2.0 Site Characteristics

DAVIS-BESSE NUCLEAR POWER STATION
UNITS NO. 1, 2, & 3

FIGURE 2.2

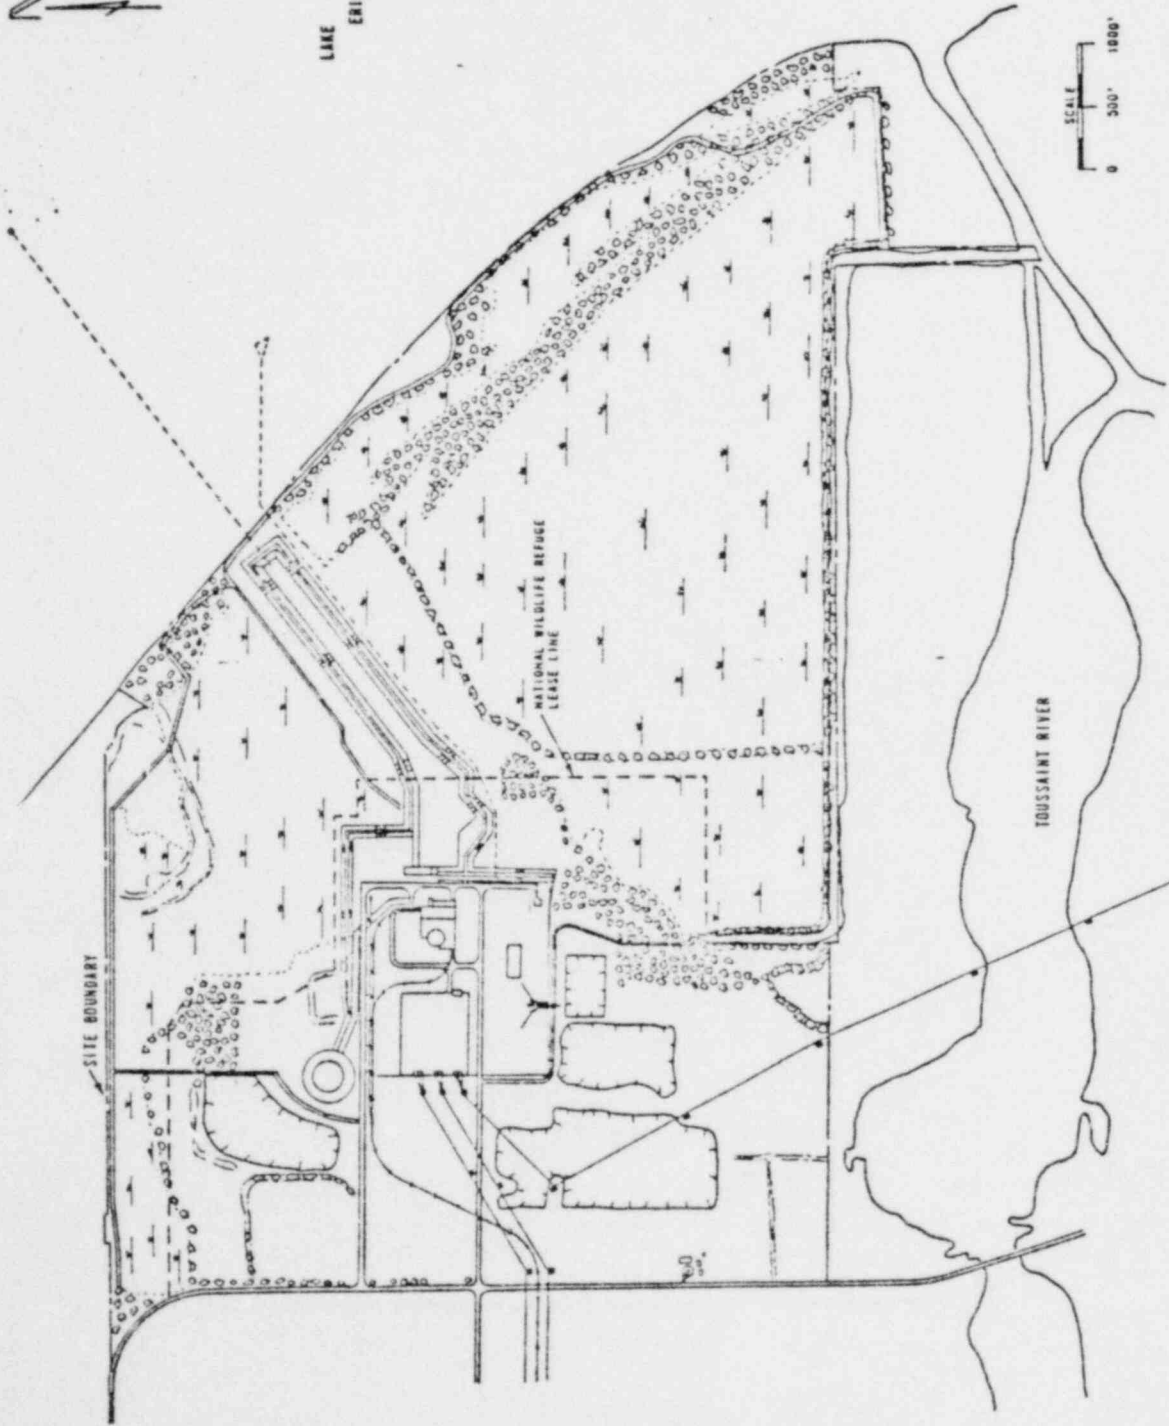
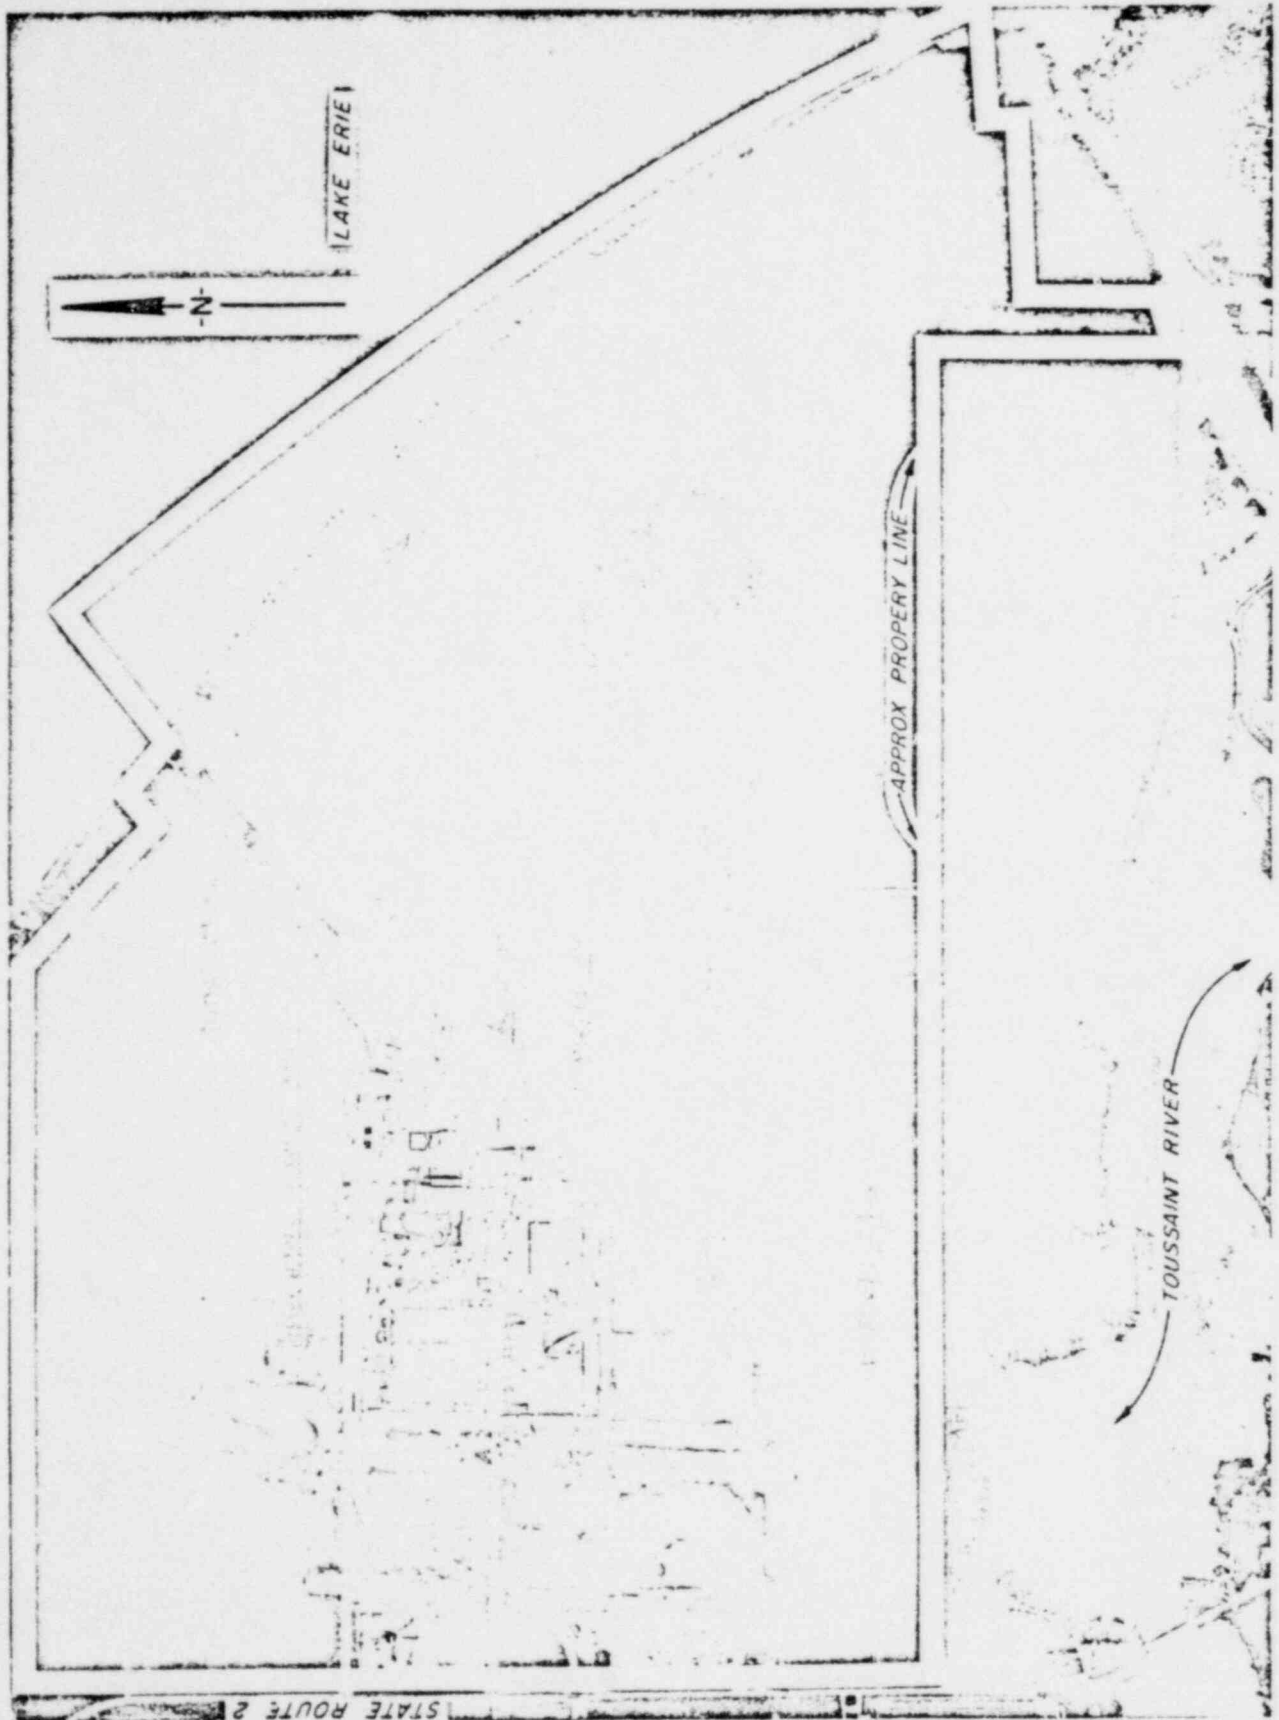
The applicants have specified a minimum exclusion area distance of 732 meters (2400 feet) for the Davis-Besse reactor. The applicants have specified a low population zone (LPZ) with a radius of 3,218 meters (2 miles) Figures 2.2 and 2.2a show the exclusion area for the site.

We have concluded that the adjacent land uses have been adequately considered and are not critical with respect to the safety of the plant.

On the basis of the applicant's specified population center distance, minimum exclusion area and low population zone, our analysis of the onsite meteorological data from which atmospheric dilution factors were calculated (see Section 2.3 of this report), and the calculated potential radiological dose consequences of design basis accidents discussed in Section 15.0 of this report, we have concluded that the exclusion area, low population zone, and population center distance meet the guidelines of 10 CFR Part 100, and that the Davis-Besse site is acceptable.

FIGURE 2.4

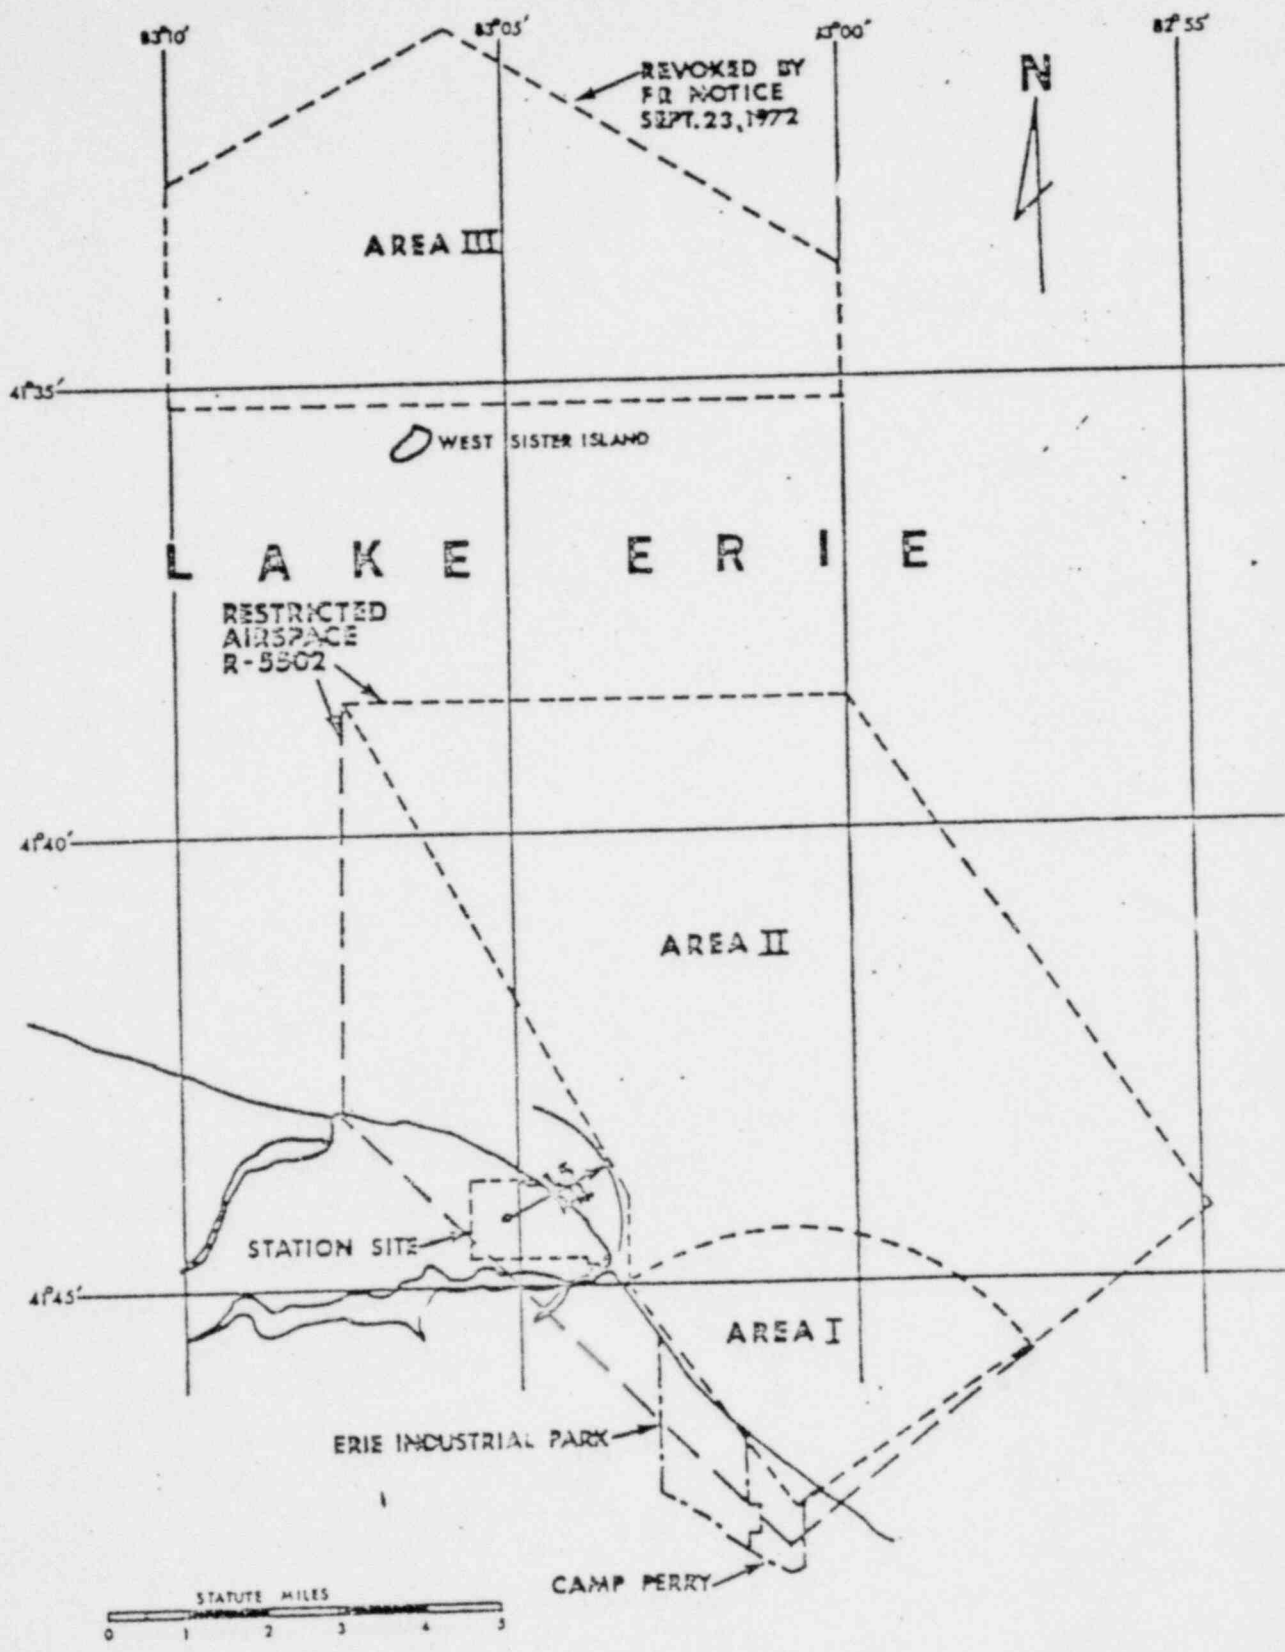
The Restricted Lake Areas as shown in Figure 2.4 (Areas I and II), with their closest boundary offshore from the station site and 1-1/2 miles from the station structures, are limited to use as impact areas for small arms, artillery, and antiaircraft artillery.

On the basis of our review of the present use of these facilities, we conclude that the present activities at these ranges have not changed, since the construction permit review, in a way that would increase the hazard to the plant, and we conclude that these activities will not endanger the Davis-Besse Nuclear Power Station.
